Access Compliance Report Public Rights-of-Way (Curb Ramps)

Intersection ID: 10032880Main Street: NATIONS_FORD_RDCross Street: N/ALocation:NEADA ID: 29CCE050DA36Ramp Type: ParaDiagInitial Pass/Fail: FailOverall Compliance: NoSeverity Score: 26.25

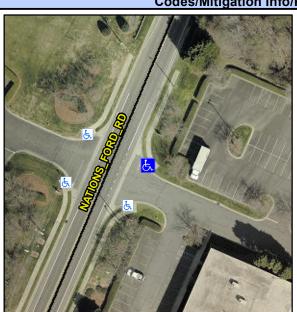
R304.3.2, R304.5.3

Field Measurements/Component Compliance					
Compliance Description		Data	Compliance Description		Data
N/A	Ramp Length LT (in)	55.0	N/A	Ramp Length RT (in)	59.0
Yes	Ramp Width LT (in)	107.0	Yes	Ramp Width RT (in)	107.0
Yes	Ramp Slope LT (%)	2.2	No	Ramp Slope RT (%)	12.1
Yes	Ramp XSlope LT (%)	1.9	No	Ramp XSlope RT (%)	3.0
N/A	Landing Length (in)	N/A	N/A	DWS Provided?	N/A
N/A	Landing Width (in)	N/A	N/A	DWS Contrast?	N/A
N/A	Landing Slope (%)	N/A	N/A	DWS Length (in)	N/A
N/A	Landing X Slope (%)	N/A	N/A	DWS Full Width?	N/A
N/A	Landing Curb? (Y/N)	N/A	N/A	DWS Offset (in)	N/A
N/A	Shared Landing?	N/A			
N/A	Gutter Ponding?	N/A	N/A	Gutter Slope (%)	N/A
N/A	Gutter Lip Ht (in)	N/A	N/A	Gutter X Slope (%)	N/A
N/A	Painted X Walk1?	No	N/A	Painted X Walk2?	No
	X Walk 1 Direction	To NW		X Walk 2 Direction	To SW
N/A	X Walk 1 Width (in)	N/A	N/A	X Walk 2 Width (in)	N/A
	X Walk 1 Slope (%)	1.5		X Walk 2 Slope (%)	8.6
	X Walk 1 X Slope (%)	6.3		X Walk 2 X Slope (%)	1.2

Remove & Replace Curb Ramp With Two New Directional Ramps or Equivalent.
